**MAJOR PROJECT ASSESSMENT:
CONCEPT PLAN FOR A MIXED USE
RESIDENTIAL, COMMERCIAL & RETAIL
DEVELOPMENT**

MP09_0029

***63-77 West Parade, West Ryde
Proposed by HOUSING NSW***

Director General's Environmental Assessment
Report

Figure 10. Photomontage (left) compared to existing situation (top right) when viewed from Terry Road (bottom right) [Base Image Source: PPR]

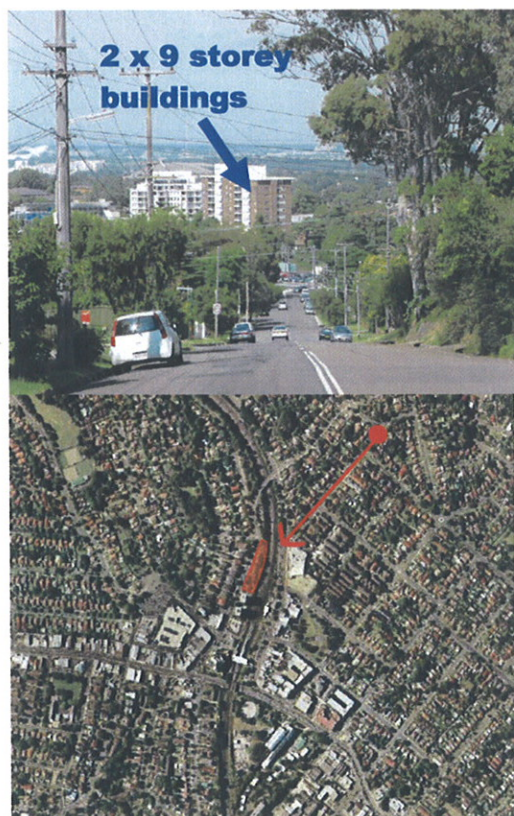
Further, the Department considers that the massing of the proposed building envelopes, in particular Building A, would satisfactorily integrate into the surrounding built form (both existing and approved) when viewed from both Victoria Road approaching West Ryde Village from the southeast, and also from Terry Road approaching West Ryde Village from the northeast as detailed in the two photomontages provided as part of the PPR (**Figure 10 & 11**).

Figure 12. Separation distances between buildings, and proposed modifications [Base Image Source: PPR]

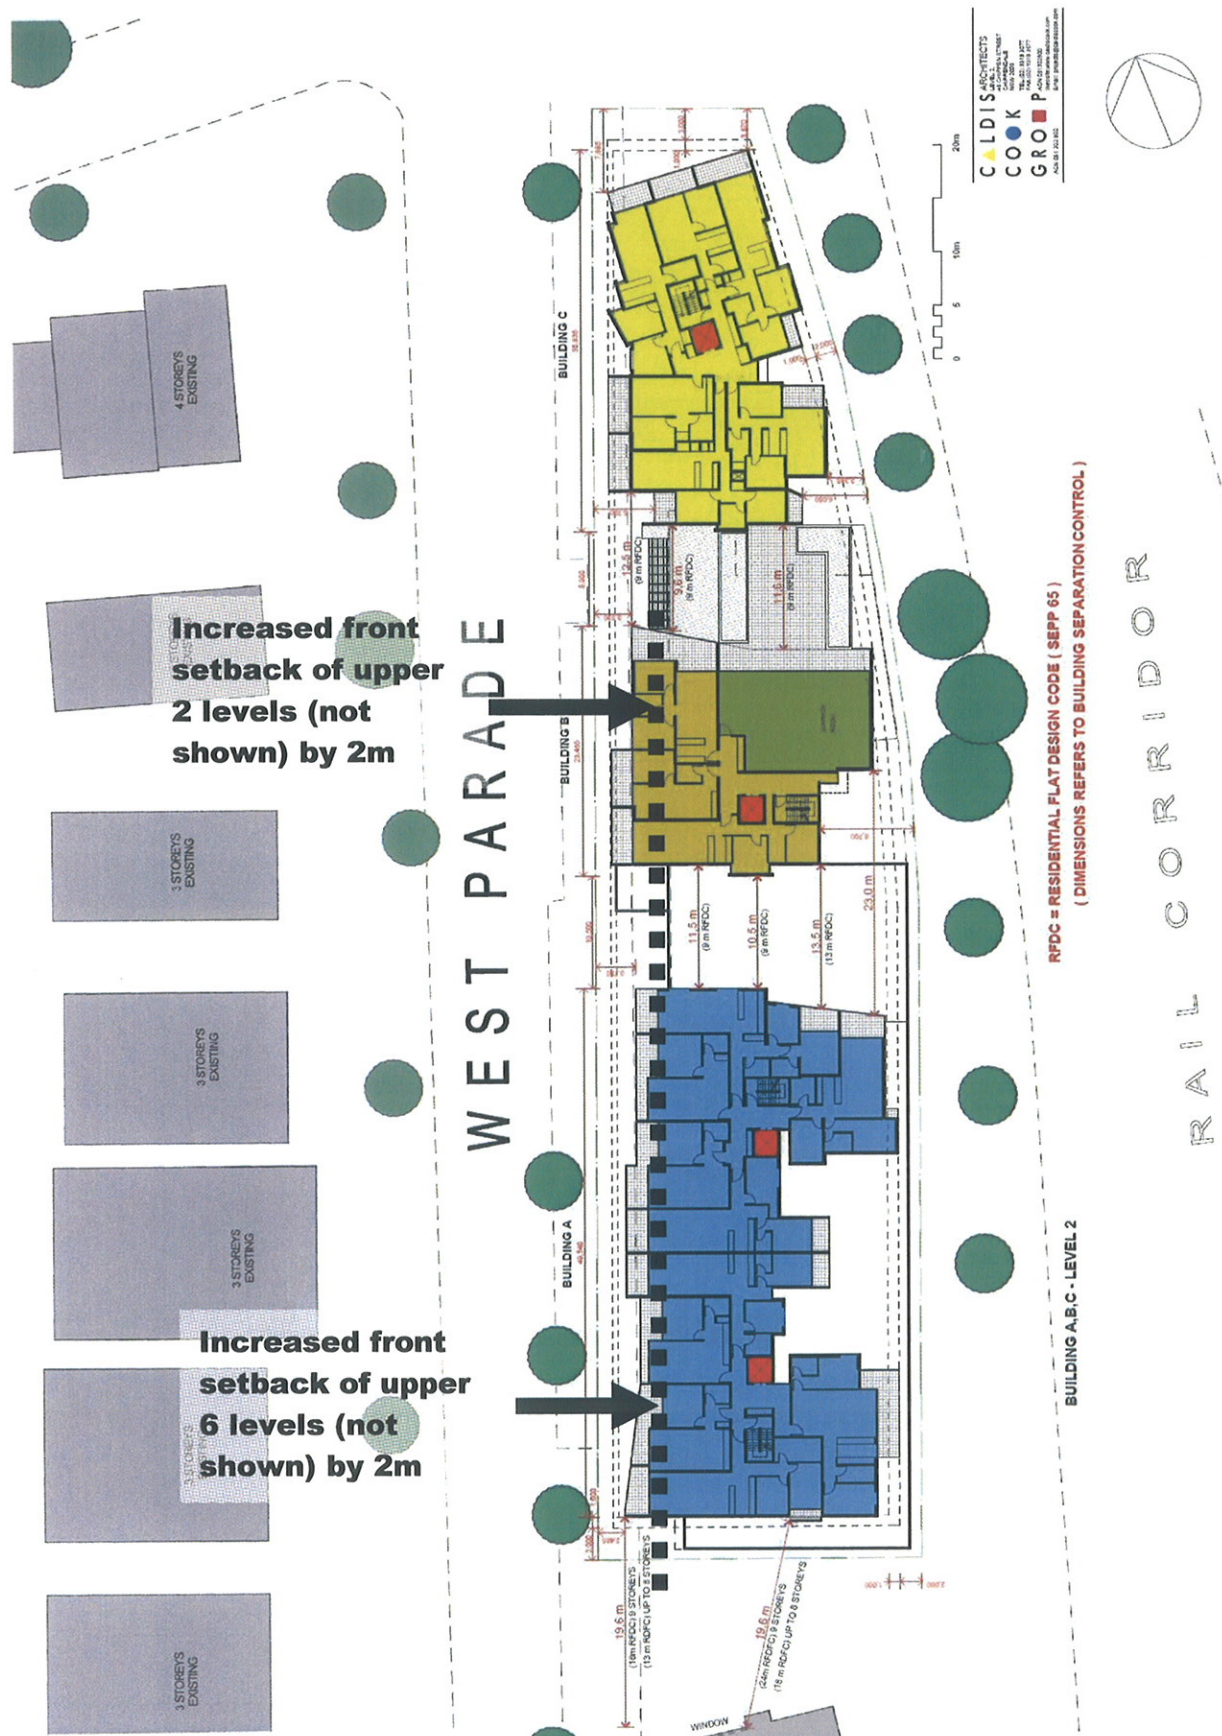
The Department considers that the street wall height and scale of Building A impacts on the pedestrian scale in West Parade. As such it is recommended that the proposed front setback of the upper 6 levels of Building A be increased by 2 metres from the front wall of the levels below. The Department considers that this additional setback would provide the following outcomes:

Council has provided comments in response to the PPR regarding setbacks and recommend that the top 2 storeys of Building B be setback from the main front wall to ensure a better relationship between the 6 storey element of Building A. Council has also recommended that the top 2 storeys of Building C be setback from the main front and side walls to provide a better relationship to the detached dwelling houses diagonally opposite.

The Department agrees that the 8 storey height of Building B (as proposed) interrupts the transition of building bulk across the site, however that 8 storeys could be supported provided that additional upper levels are setback. As discussed previously, the Department recommends that the PPR be modified by requiring an additional 2 metre front setback at the upper 2 levels of Building B.

Overall, these increased setbacks would equate to a potential maximum loss of approximately 384m² of social residential and private residential GFA, allowing a total GFA of approximately 12,765m² and FSR of approximately 3.4:1 which is closer to that proposed in the EA (Figure 12 & Table 4).

Photo 8. The northern elevation of 57-61 West Parade

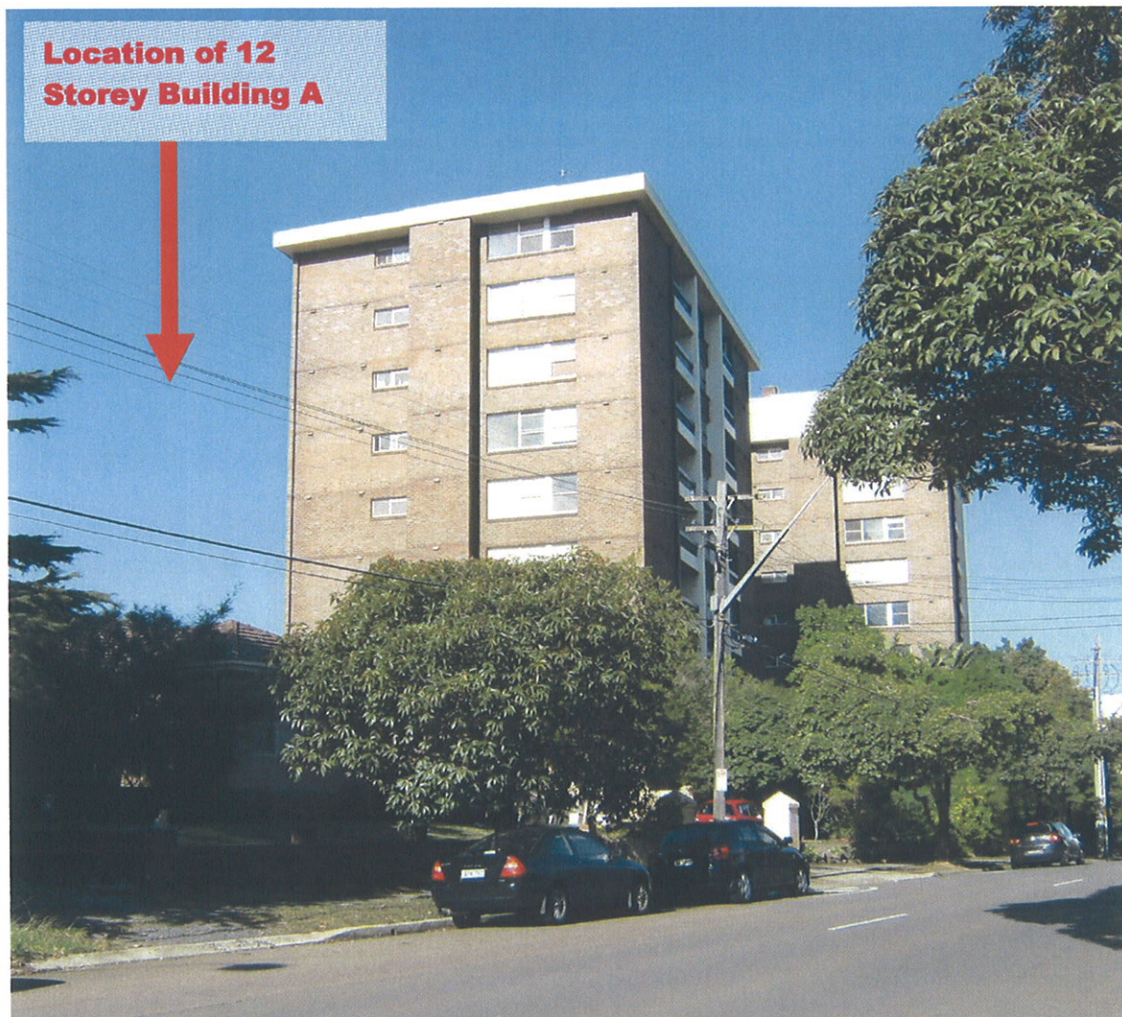
The majority of the northern elevation of this adjacent building, which contains a large window and smaller secondary (high level) window serving each habitable floor of only a portion of all units, would be variously overshadowed between the hours of 9am-12noon on 21 June. At 12 noon, a portion of the large northern window will receive direct sun, which would increase during the afternoon to the entire window receiving full sun by early afternoon. At 3pm on 21 June, all windows of this elevation will be in full sun. West facing windows/balconies of these apartments would be unaffected by shadows cast by the proposal from late morning.

The Department is satisfied that solar access to surrounding residential properties will not be unreasonably affected, particularly the occupants of the 9 storey building adjacent to the south, as the main living area/private open space of all units affected by the proposal would maintain a minimum of 3 hours of direct sunlight between 9am and 3pm in mid winter, as required by the Residential Flat Design Code. Further, the recommended modifications to the PPR to increase front setbacks will further lessen any overshadowing impact on surrounding residents.
